ISO-2 Project WIPP Independent Oversight – DE-AC30-06EW03005

AN EVALUATION OF THE APPROVED AND PROPOSED PANEL CLOSURE SYSTEMS AT THE WASTE ISOLATION PILOT PLANT

October 2006

PECOS MANAGEMENT SERVICES, INC.

Figure 2. Approved Panel Closure System - Explosion isolation wall and Salado Mass Concrete barrier with DRZ removed.

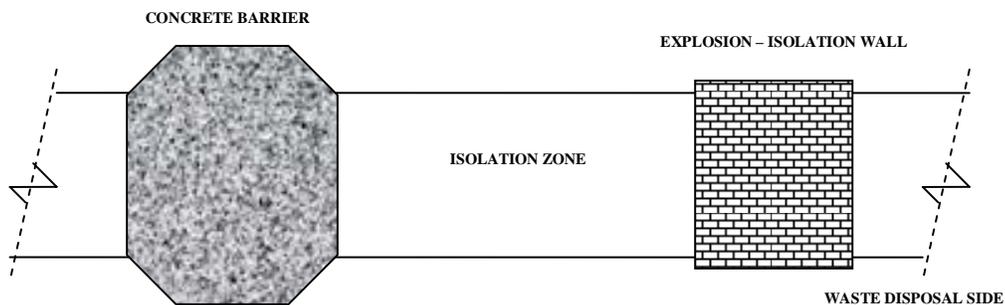
As shown in *Figure 2*, the approved panel closure system consists of a 12-foot-thick explosion/isolation wall constructed of dense concrete masonry units (CMU) followed by a 28-foot-thick SMC monolithic concrete barrier, which is anchored in a circular-type groove cut into the host rock. Cutting of the groove results in removal of most of the DRZ. Removal of the DRZ *prior* to construction of the monolithic concrete barrier portion of the panel closure system insures consistency in the initial characteristics of the interface between the Salado host rock and the concrete barrier. The bottom of the monolithic concrete barrier is keyed into marker bed 139, and the top keys into the clay G zone, essentially blocking diffusion of VOCs through the cracks in the DRZ. The two barriers are separated by an isolation zone. The sequence for panel closure begins with the closure of individual rooms after they have been filled with wastes. Module IV of the HW permit requires ventilation barricades to be installed on each filled disposal room and refers to Attachment M2 of the HW permits which states, “*Once a disposal room is filled and is no longer needed for emplacement activities, it will be barricaded against entry and isolated*

1. The EPA decision to include a panel closure system of the type proposed by the DOE in the CCA is justified, but the requirement that it be the most robust of the four options presented with the added use of SMC is not scientifically supported.

6. Replacement of the approved panel closure system design with a more constructible design is desirable and perhaps essential, as it will reduce safety and health risks to workers.

Figure 3. Explosion isolation wall in combination with the run of mine salt backfill.

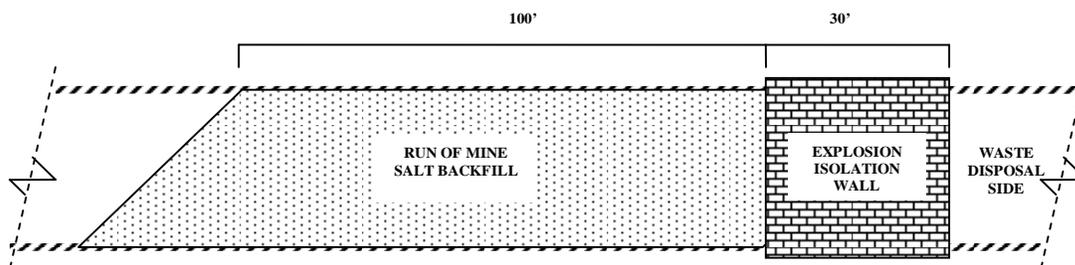
Subsequent to the EPA stipulation of the required panel closure system and the consequent inclusion of that requirement in the HW permit, DOE expressed concern that the use of SMC during installation of the approved panel closure system could have possible impacts on waste management activities in the WIPP underground. This concern was reinforced by the erratic results of several test pours of the SMC formulation that was specified in the WIPP HW permit.⁹ As a result, in 2002, DOE submitted a permit modification request (PMR) to the NMED and to EPA requesting approval of an amended waste panel closure (WPC) system.¹⁰ The PMR states that the alternative system proposed by DOE (*Figure 3*) is somewhat simpler in design, less expensive, much faster to construct, equally protective, has less impact to facility operations, and has a higher certainty of success. It consists of a 30-foot-thick explosion-isolation barrier backed up by a 100-foot run of mine salt backfill.

Prior to constructing the barrier, any loose materials from the ribs, floor, and ceiling of the drift to be closed would be removed in order to create a clean and even surface, and dense CMUs would then be laid with offsetting mortar joints. (The composite permeability was shown to be on the order of 10^{-15} m²).¹¹

7. The WPC system design is more than adequate to meet requirements, but close monitoring of the mortar emplacement quality is necessary to ensure the design criteria for permeability is met if that criteria continues to be used. Also, the design reports did not demonstrate that the 100 feet of salt backfill can be uniformly placed against the drift ceiling, thereby preventing the formation of a more highly permeable flow channel due to non-uniform salt compaction by salt creep.

8. The utility of the 100-foot-long salt backfill component of the WPC system is questionable for most panels, given that its contribution is not expected to come into play for 30 years, and the potential for a methane explosion is not projected to occur for at least 18 years (and most probably not for 30 years—if at all).

Figure 4. Methane concentrations in the waste panel over time (from Detailed Design Report for Operational Phase Panel Closure System 1996 – Reference 14).

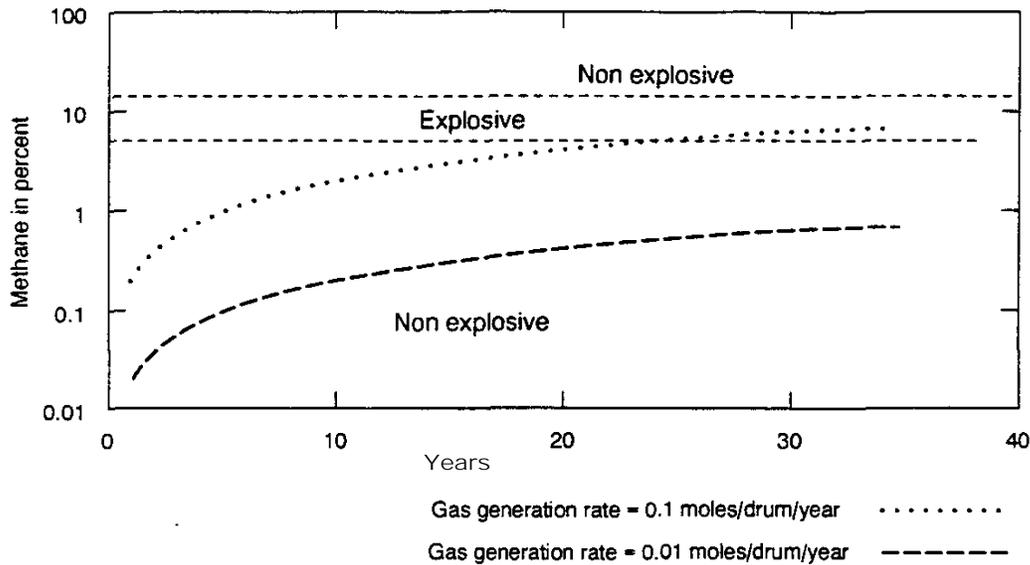
This estimate appears to be based upon two key assumptions: 1) that the oxygen (O₂) concentration in the waste panel remained at 18 percent, and 2) that the biogeneration of methane would start within a short period of time (months at most) of panel closure. With respect to the O₂ concentration in the panel atmosphere, it would appear that if there was enough brine inflow to cause contact with large amounts of iron in the waste, that iron would rust—thereby depleting the O₂. As the O₂ concentration decreases, the concentration range of methane that is explosive narrows and more time is required to reach a methane concentration with explosion potential.²

The second assumption, which has a larger impact on the estimate of a potential explosion, is based upon two further assumptions: 1) the influx of sufficient brine into the waste panel to sustain the biogeneration after closure, and 2) the presence and survival of microorganisms necessary for the biogeneration. As indicated above, there are no data presented in the documentation reviewed for this report to indicate there will be any significant amount of brine inflow to the closed waste panel during the operating life of the WIPP.

estimate that an explosive condition could develop in 20 years based upon the assumption of 0.1 moles/drum/year gas generation is overly conservative. In fact, due to the fact that the very small volume of water in the waste (<1% by volume) is insufficient for development of either humid or saturated conditions in the drums—the slow rate of brine flow into the closed waste panel, the low humidity associated with brine due to the low vapor pressures, and the likelihood that the gas generation rate will be substantially less than 0.1 moles/drum/year—it is not unreasonable to assume that explosive conditions will not develop in the closed waste panel during the 35-year design life of the repository.
